CERTIFICATE OF APPROPRIATENESS

Property: 1802 Harvard Street, Lots 14 & 15, Block 105, Houston Heights South Subdivision. The property includes a historic three-story wood frame (with basement) 5,341 square foot single-family residence and a two-story 812 square foot carriage house situated on a 14,520 square foot corner lot.

Proposal: Alteration – windows, door.

PROPOSED FRONT (WEST)

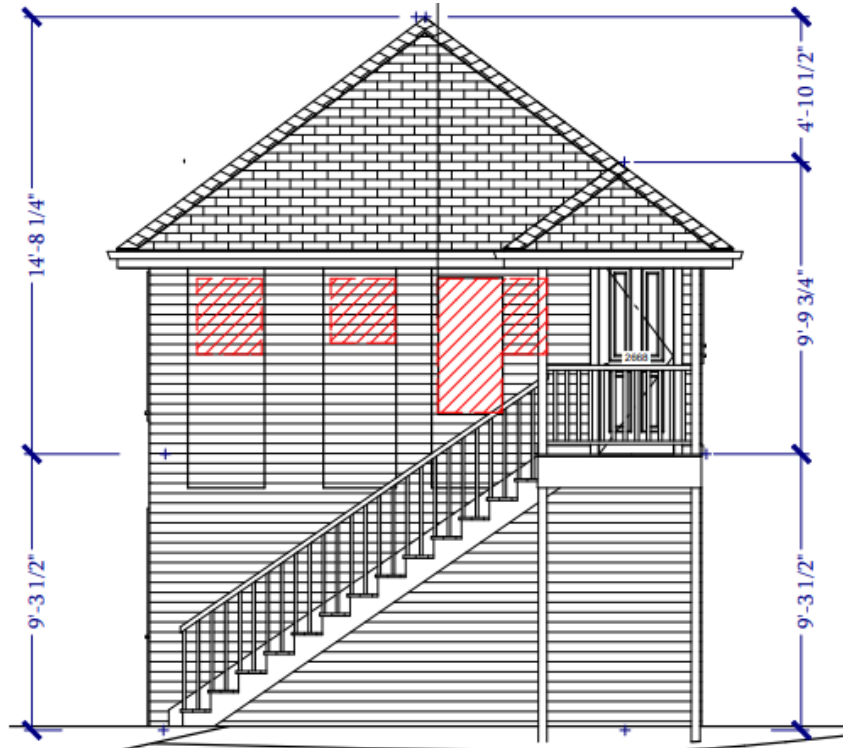
The black rectangle was an A/C wall unit that was included on the previous 2020 COA but the applicant clarified that it is now **not** to be included and that the only change here is the garage door.
